**CITY HALL AND  
CITY HALL ANNEX  
ACCESSIBILITY SURVEY**

**July, 2007**

**CITY OF SANTA  
BARBARA**

*Building - Photo # 15*

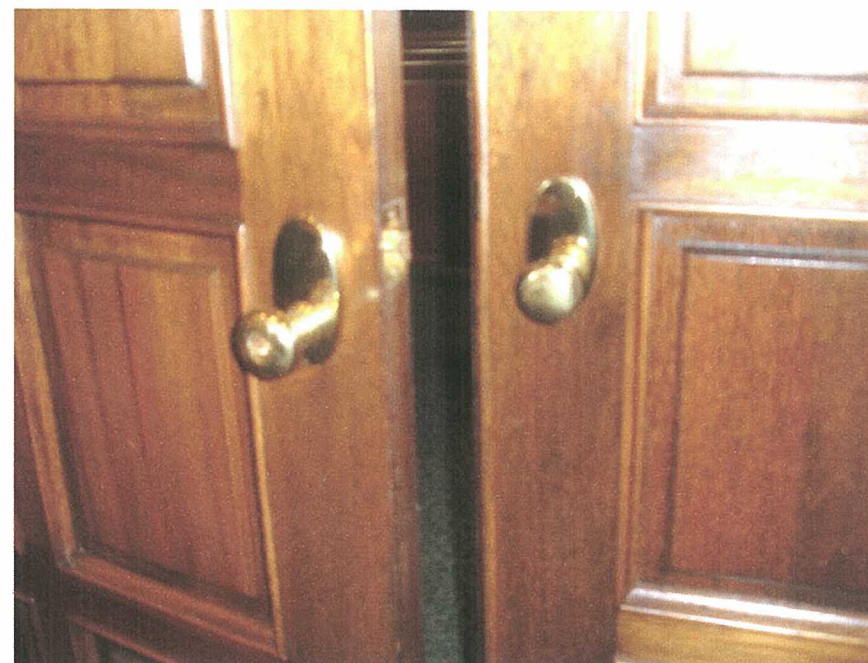
*Hardware is heavy to operate and there is no wheelchair accessibility to this staff storage area. Step does not have contrasting color striping and handrails. There is not the required tactile and Braille room identification sign.*

*Building - Photo # 17*

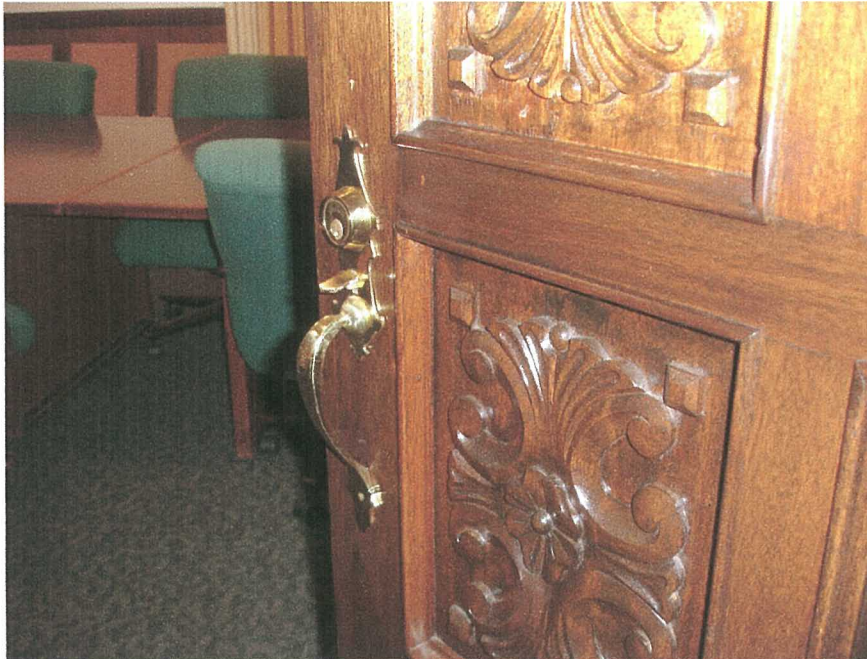
*Doorknob requires tight grasping to operate.*

*Building - Photo # 20*

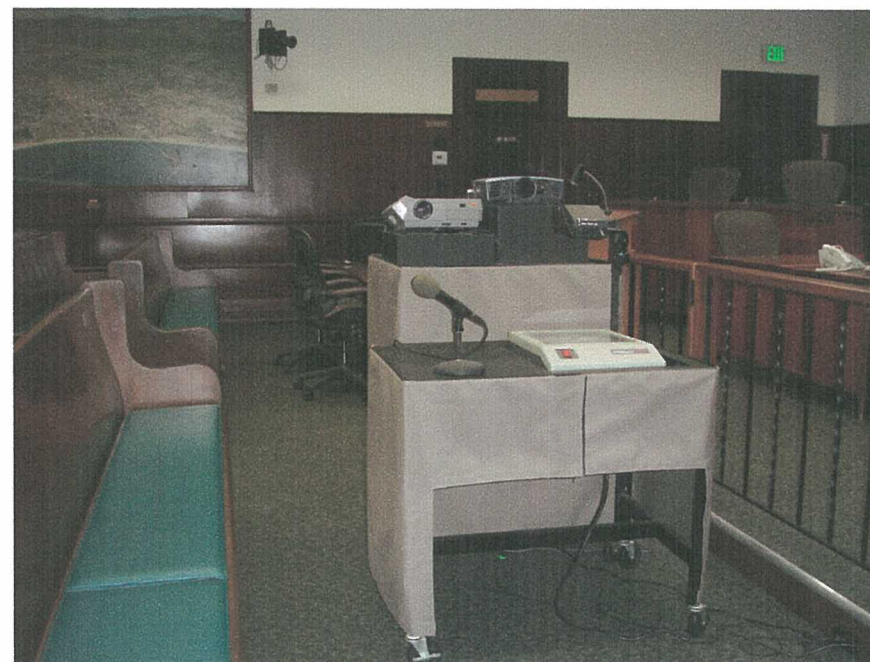
*Council chamber seating does not have designated wheelchair spaces, companion seating, semi-ambulant seating and transfer seating with the required signage.*

*Building - Photo # 23*

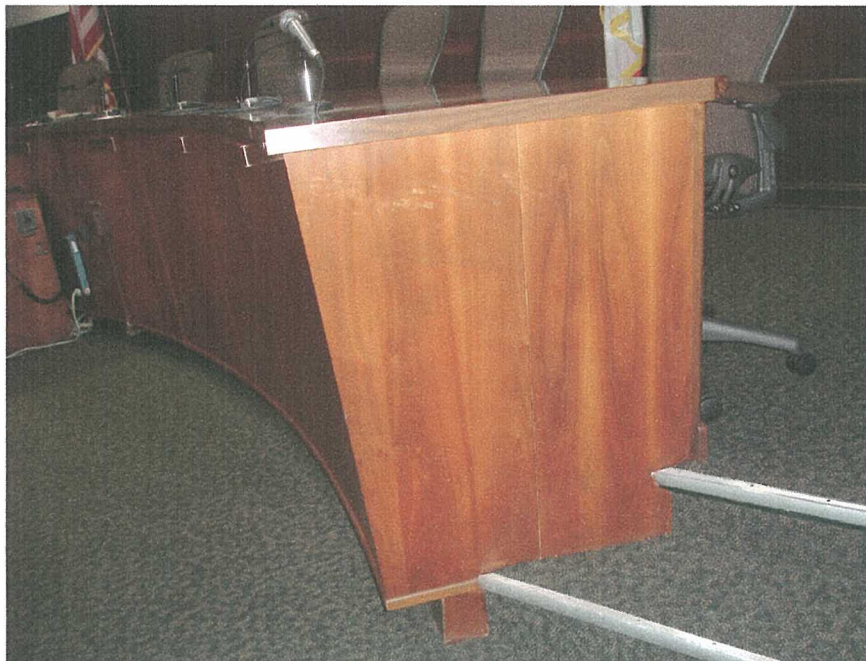
*The slide projector is mounted too high, a lower wheelchair accessible projector should be provided.*

*Building - Photo # 24*

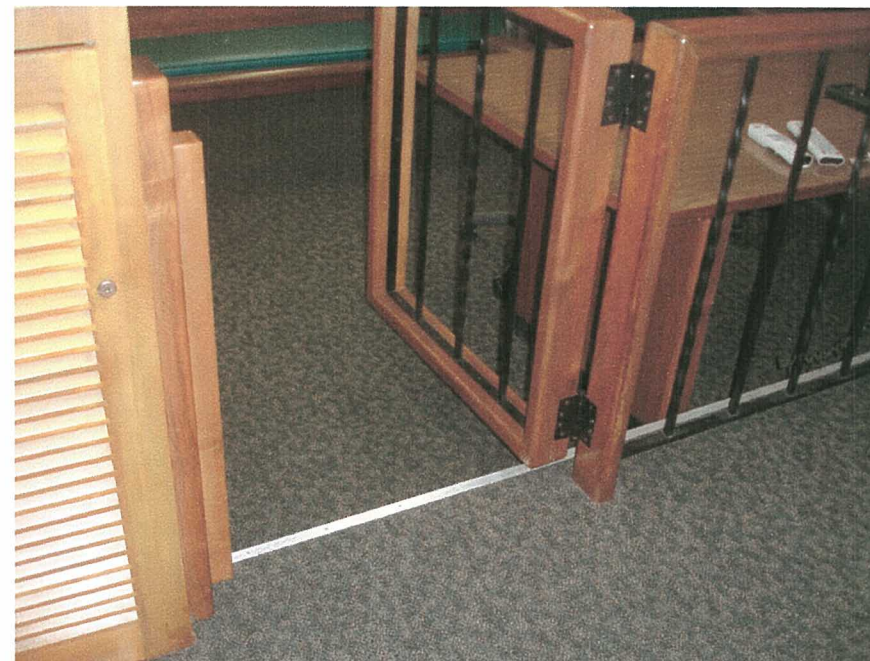
*The aluminum stair nosing is not 2" wide to be considered as contrasting color striping.*

*Building - Photo # 26*

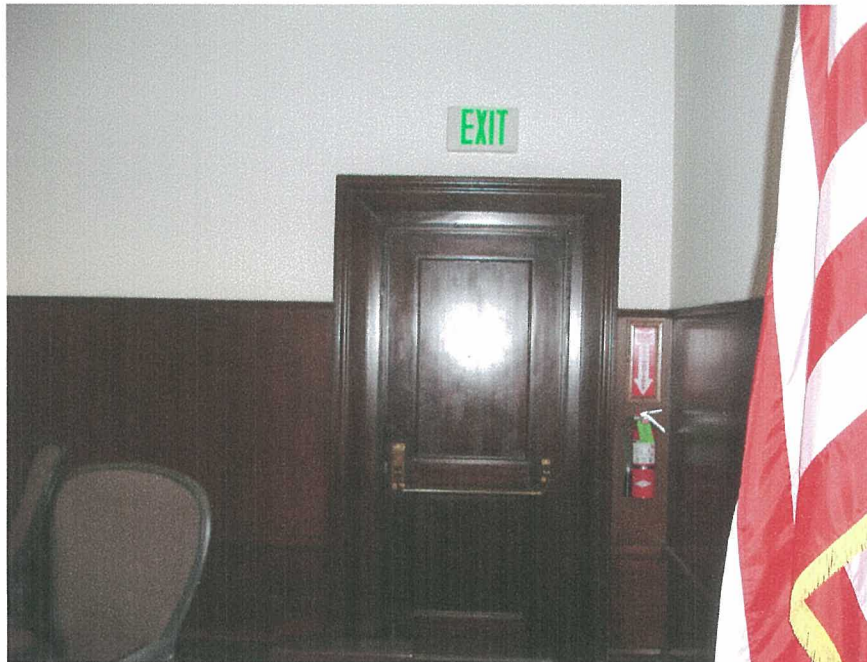
*There are no ramps to the first and second platforms. The gate is not wide enough for wheelchair users – 29 ½” each door leaf. There is not a smooth 10” kick plate.*

*Building - Photo # 29*

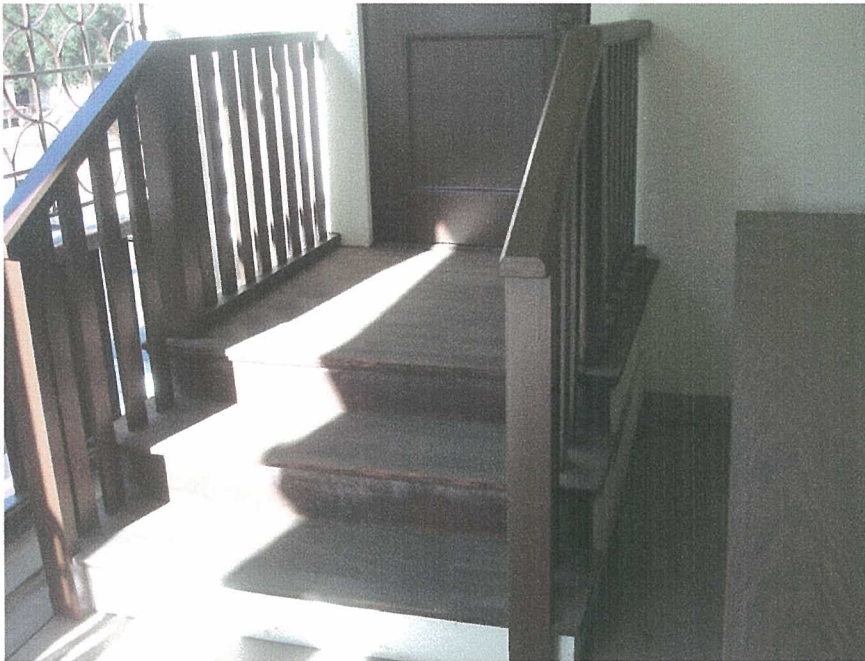
*Door leading to an office has one step. Hardware is not accessible type. There are no tactile and Braille room identification and a "NOT AN EXIT" signs.*

*Building - Photo # 30*

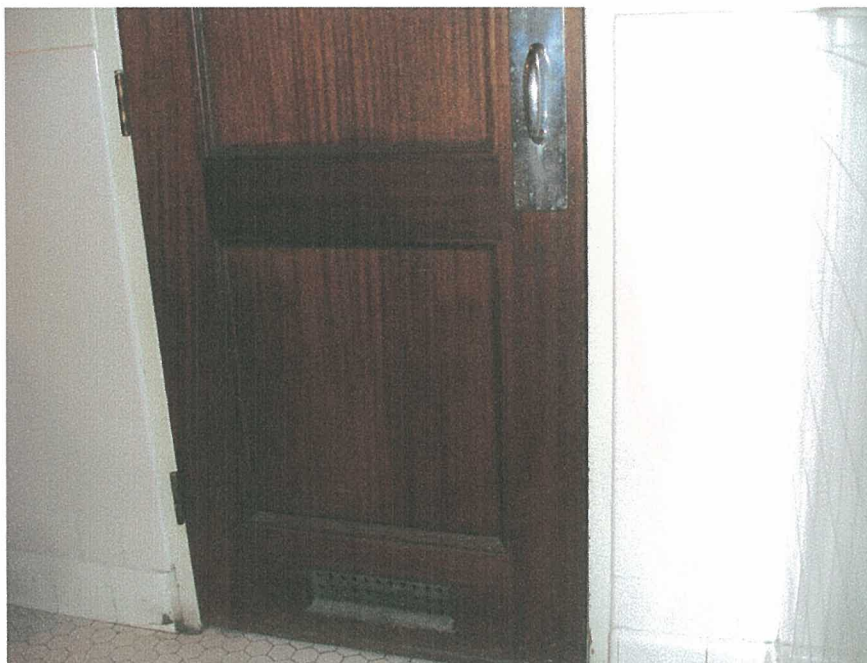
*Stairs have uneven risers 7" and top 6 5/8" high. There is no contrasting color striping at all steps. Handrails are 3 1/2" wide instead of 1 1/2" maximum diameter or equivalent shape. Handrails do not have the compliant extensions.*

*Building - Photo # 33*

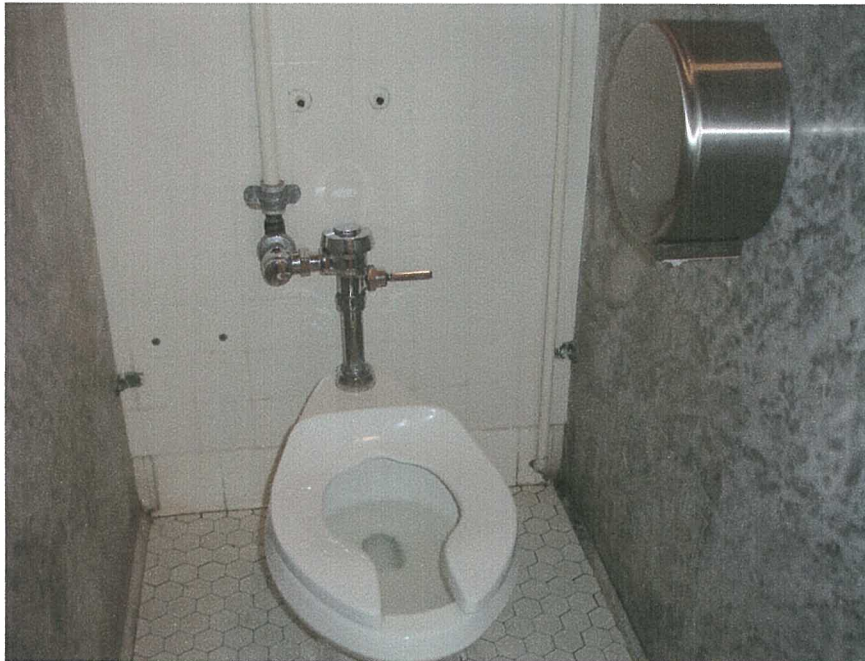
*Paper towel and soap dispensers are mounted too high. Pipes are mounted too low and interfere with the required knee clearance. There is no plumbing pipe insulation. The lower side of the vanity edge is 28 ½" high instead of the required 29" high.*

*Building - Photo # 34*

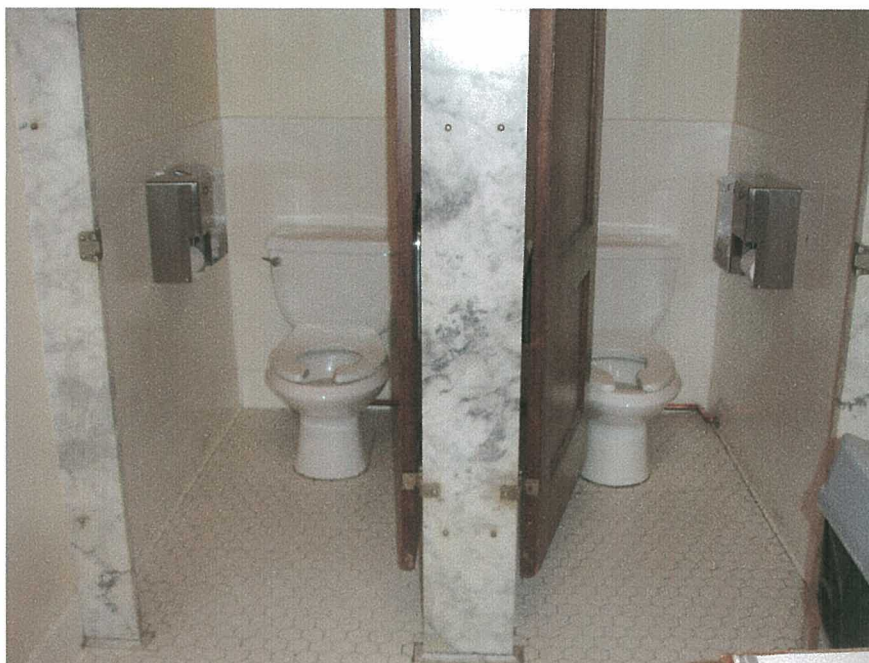
*Toilet compartments are not accessible; they are too narrow and need to be remodeled.*

*Building - Photo # 38*

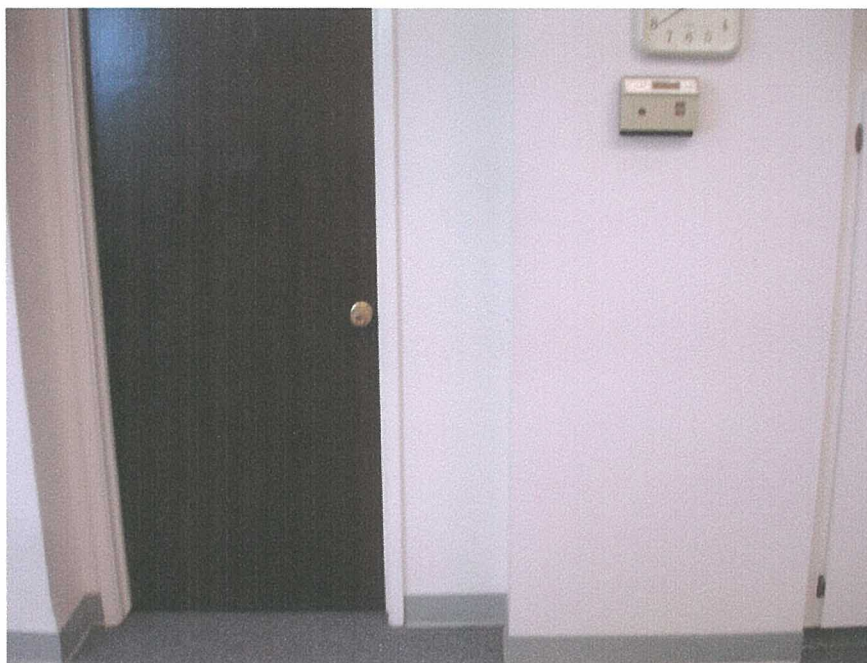
*Door hardware requires tight grasping to operate. There are not the required tactile and Braille room identification and "NOT AN EXIT" signs.*

*Building - Photo # 40*

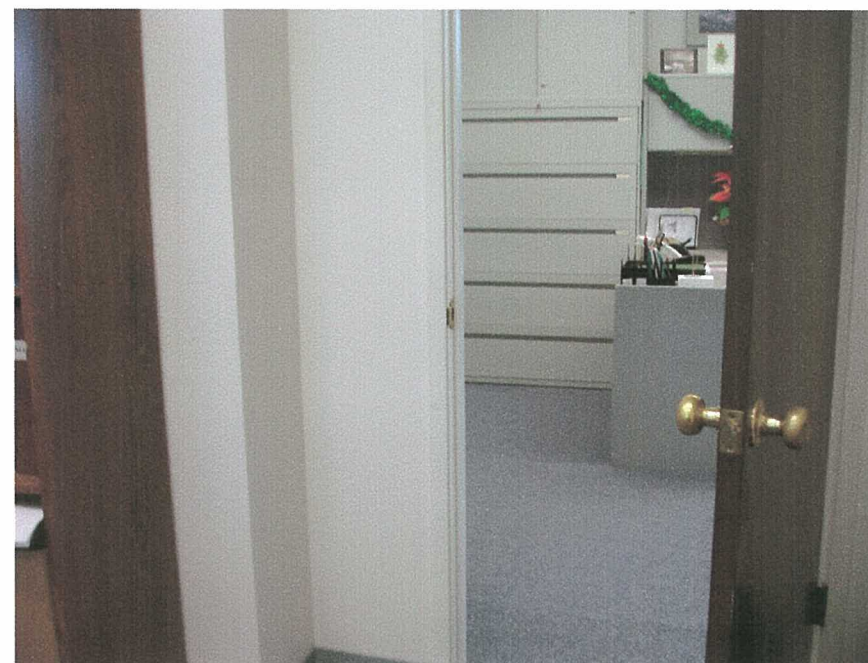
*Door hardware requires tight grasping to operate. There are not the required tactile and Braille room identification "EXIT" signs. Room temperature controls are mounted too high.*

*Building - Photo # 42*

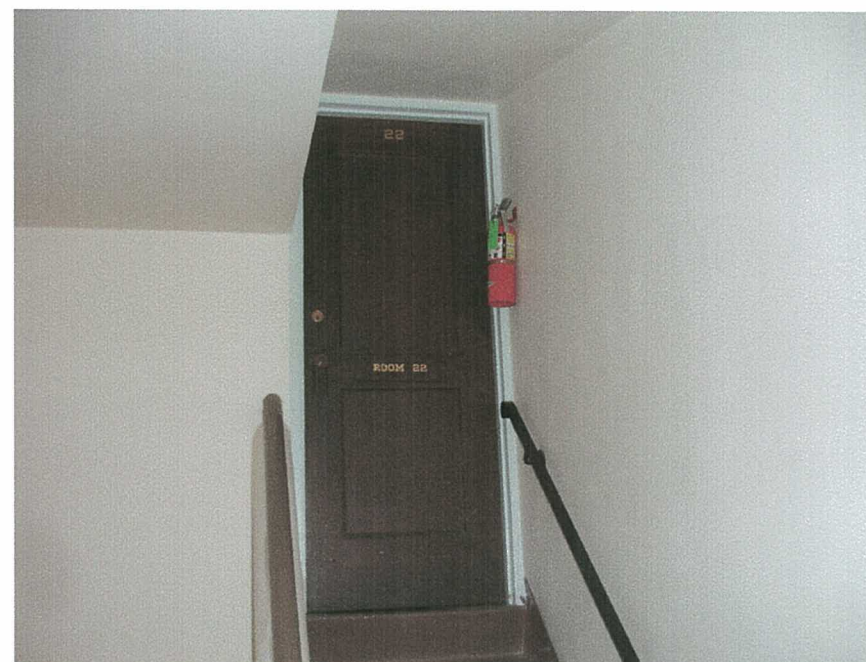
*The lower kick plate area is not smooth due to the grill location.*

*Building - Photo # 10*

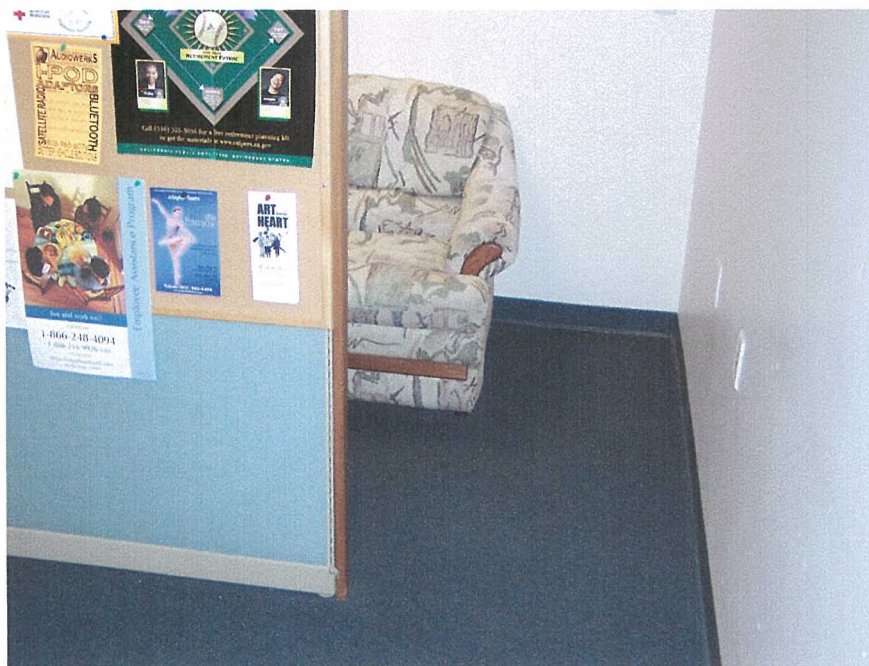
*Non-accessible sink – no knee clearance provided.  
Casework is 21" wide instead of the required 30" clear  
and 36" high instead of 34" maximum.*

*Building - Photo # 13*

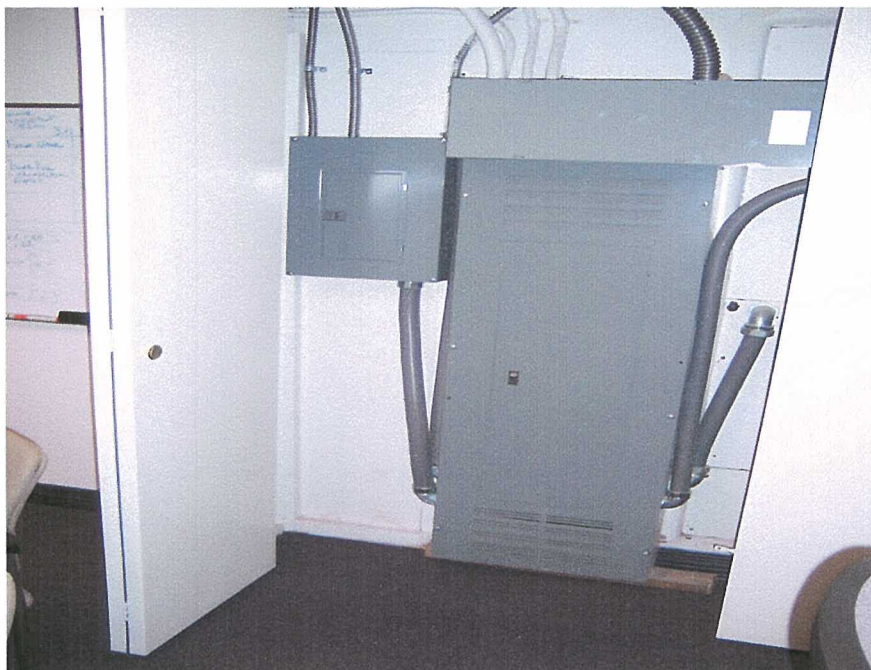
*Push buttons are recessed, requiring pinching to operate.*

*Building - Photo # 16*

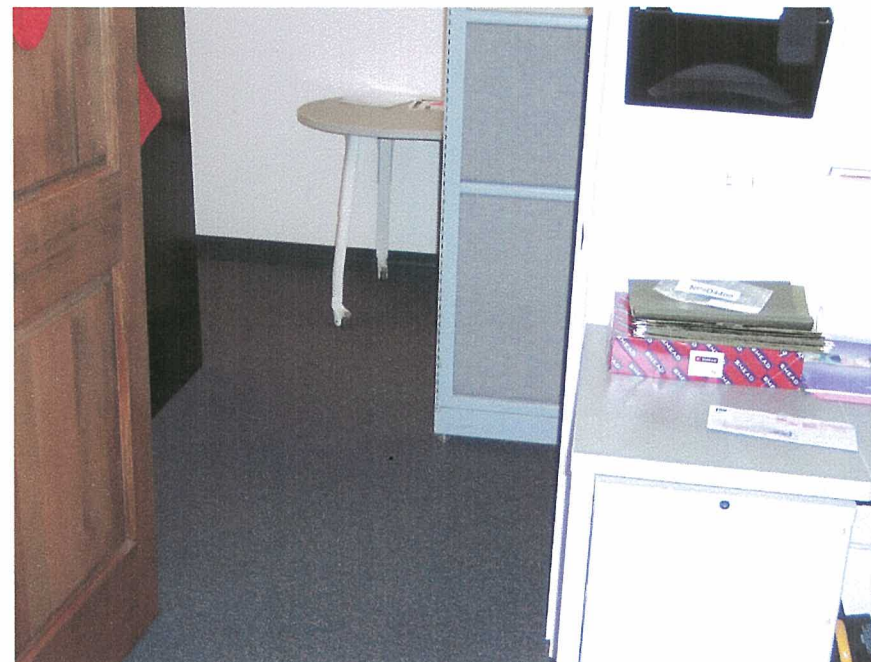
*Door hardware is not compliant and there is no tactile/  
Braille sign.*

*Building - Photo # 2*

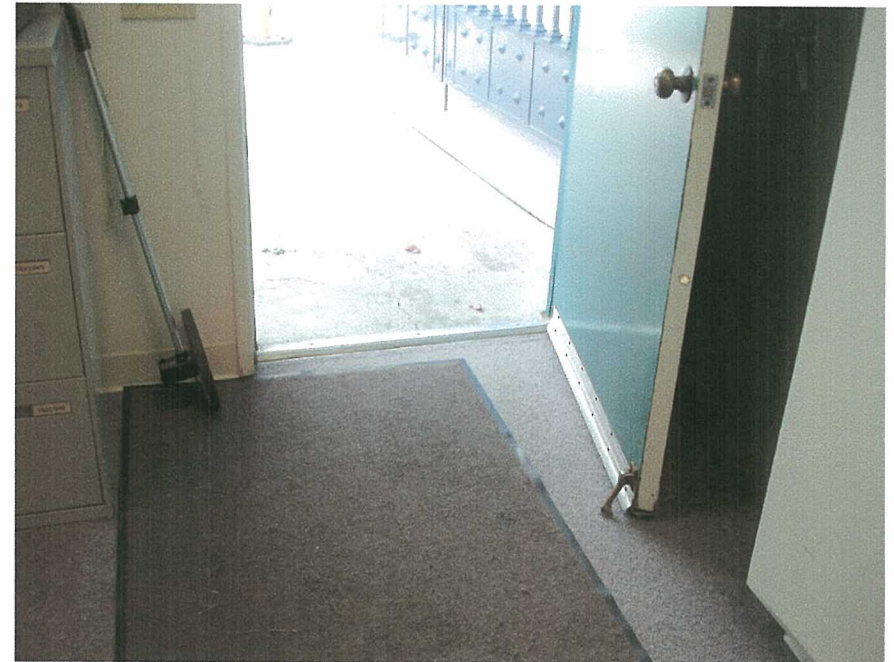
*Step makes this area not wheelchair accessible. Loose doormat needs to be secured. Door hardware requires tight grasping to operate. There is no tactile and Braille room identification sign.*
